Proposal for supplement 13 to the 01 series of amendments to UN Regulation No. 43 (SAFETY GLAZING MATERIALS)

Paragraph 2.5 of Annex 21., amend to read:

Figure 3: Determination of the datum points (example of a left-hand steering control vehicle)

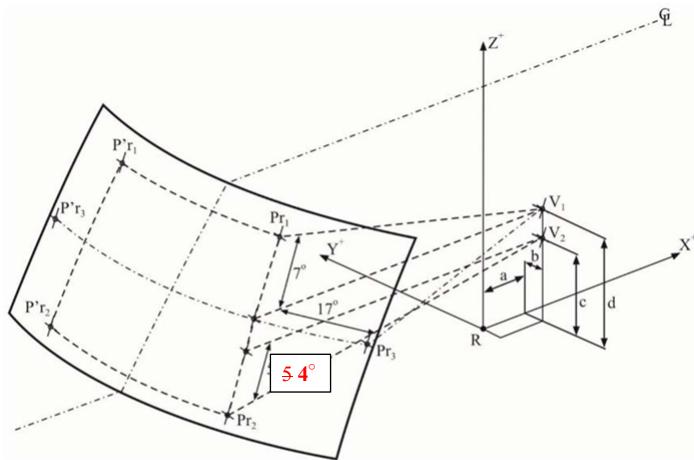
2.5. Definition of the datum points (see Figure 3)

The datum points are points situated at the intersection with the outer surface of the windscreens of lines radiating forward from the V points:

- 2.5.1. Upper vertical datum point forward of V₁ and 7° above the horizontal (P_{r1});
- 2.5.2. Lower vertical datum point forward of V₂ and 5 4° below the horizontal (P_{r2});
- 2.5.3. Horizontal datum point forward of V₁ and 17° to the left (P_{r3});
- 2.5.4. Three additional datum points symmetrical to the points defined under paragraphs 2.5.1. to 2.5.3. in relation to the longitudinal median plane of the vehicle (respectively P'_{r1}, P'_{r2}, P'_{r3}).

Figure 3 of Annex 21, amend to read:

Definition of the datum points is described in both R43 and R125. Historically, there has been an inconsistency in R125 between the lower datum point (paragraph 5.1.1.3.) and the obstruction requirement (paragraph 5.1.3.). To resolve such an inconsistency, the proposal to amend R125 (see the informal document GRSG-130-XX) harmonizes the location of the lower datum point (at 5°) of the para.5.1.1.3. to the angle of obstruction requirement in paragraph 5.1.3. (at 4°).

This proposal is to align with the proposed amendment to R125 (informal document GRSG-130-XX) regarding the lower datum point.
